ADDENDUM No. ONE

Date: June 12, 2023

Project: Mason Road Improvements, MES No. 2023-12

Water & Sewer
 Plan & Profile
 DATE: JANUARY 24, 2008
 FILE NO: 2007-28PRJ 3D
 SHEET: 5

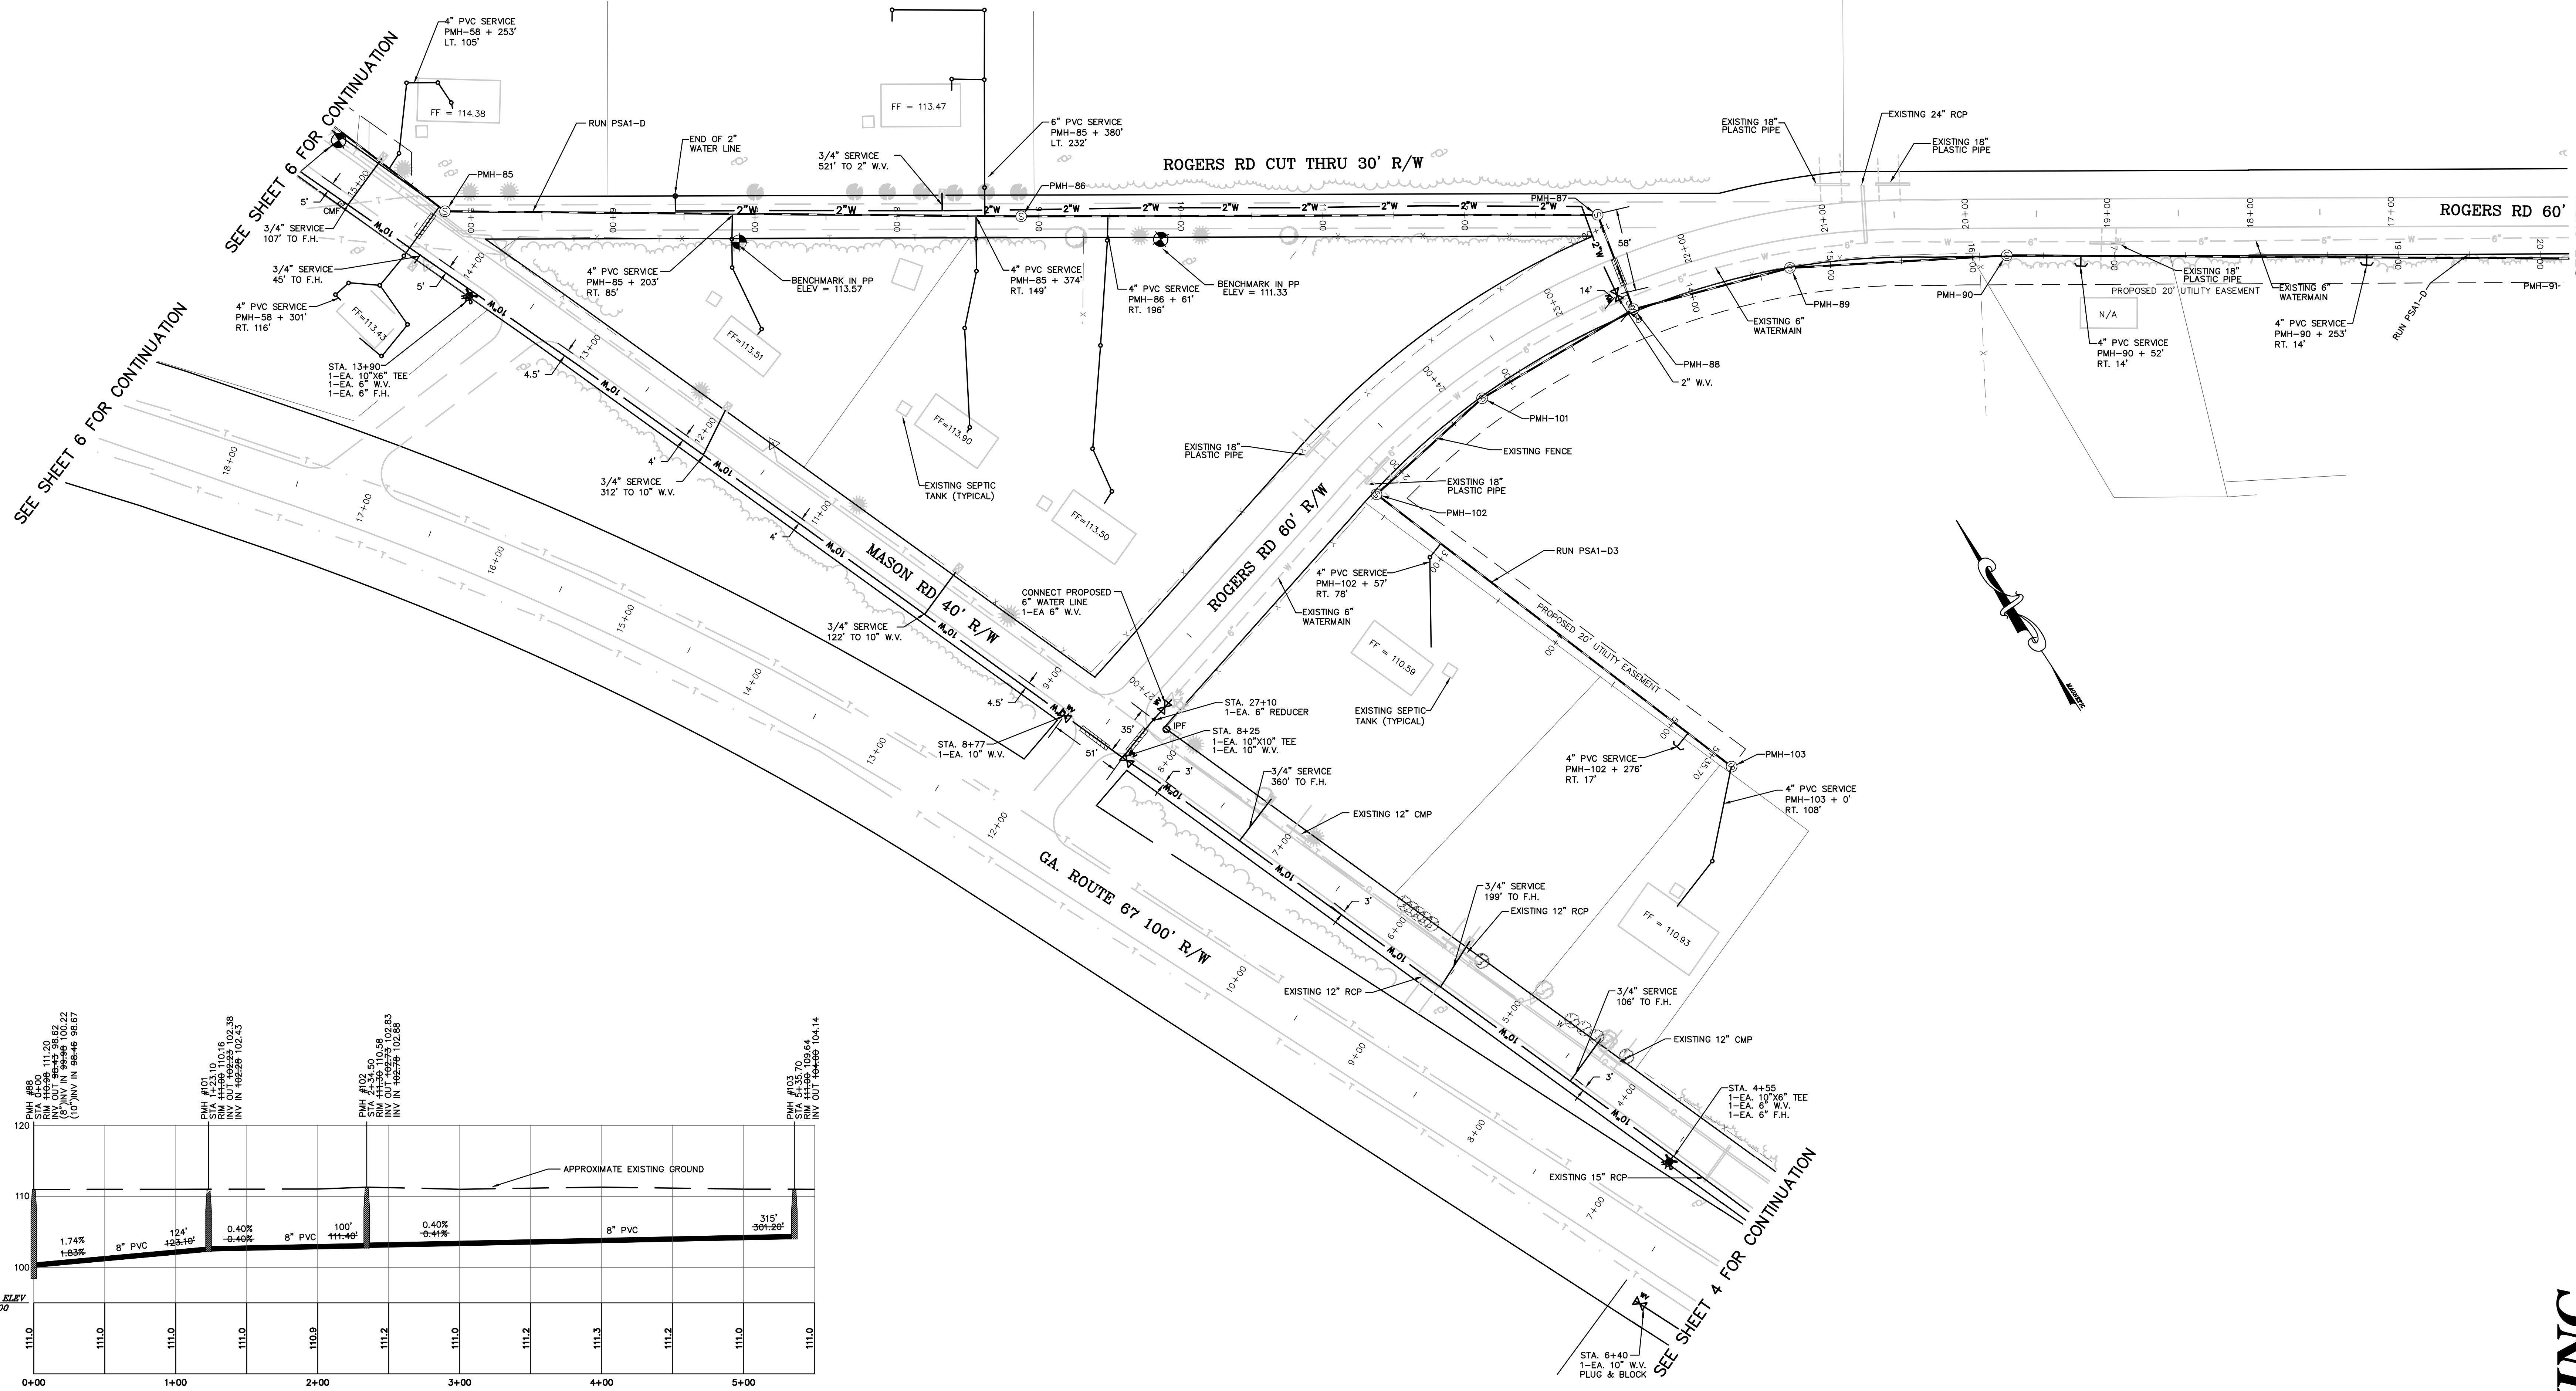
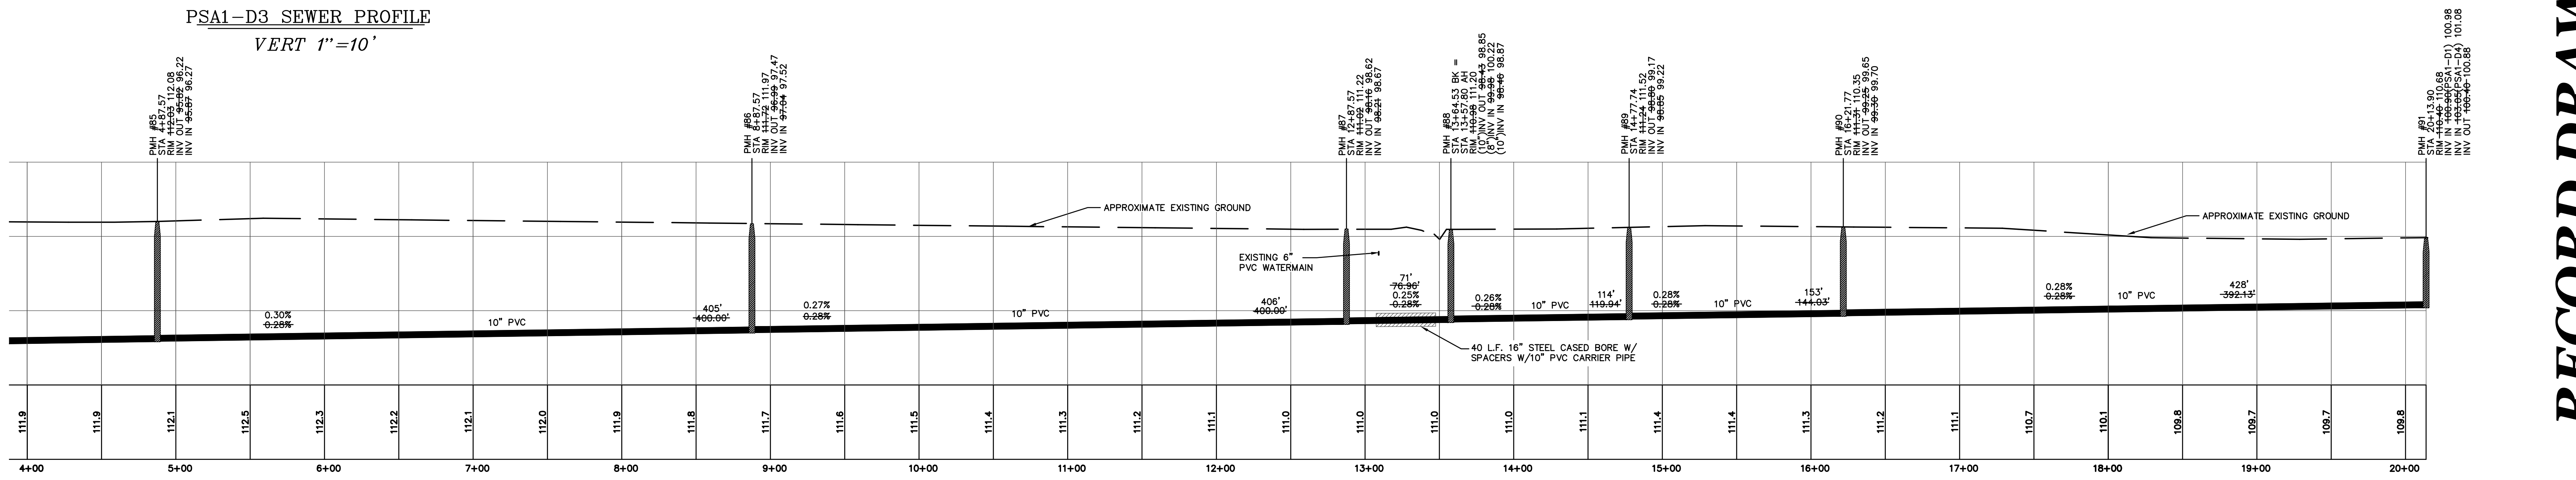
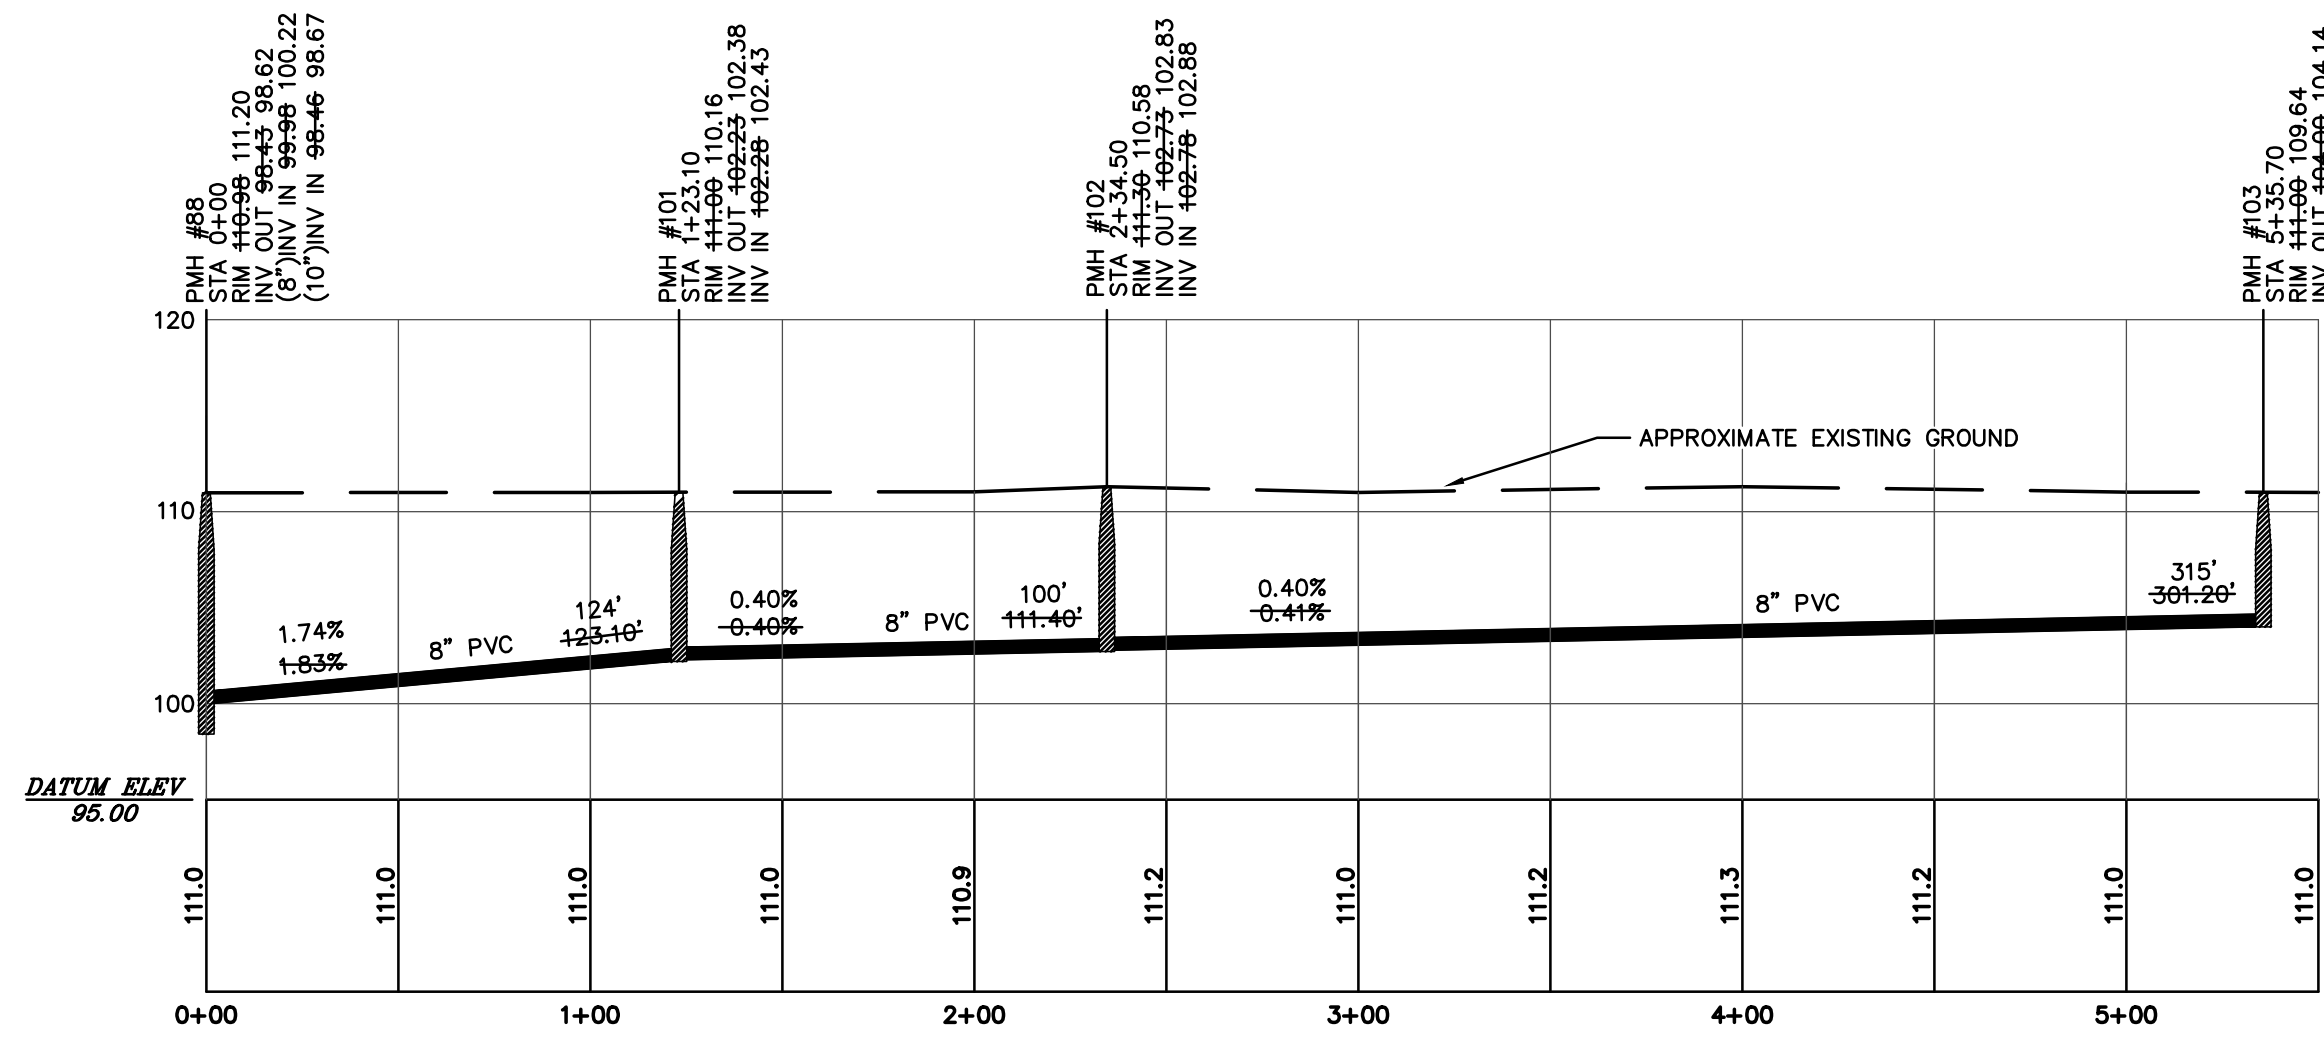
6. *It appears that some of the trees are directly over the existing water main. How are we to address this? Is stump grinding an option? Also what size is the existing WM?*

- The existing waterline is a 10" PVC main. We are providing record drawings with this clarification. We will consider grinding on a case-by-case basis where needed, so long as the stump is ground below surface elevation and the surface is clean and level for ease of maintenance in the future.
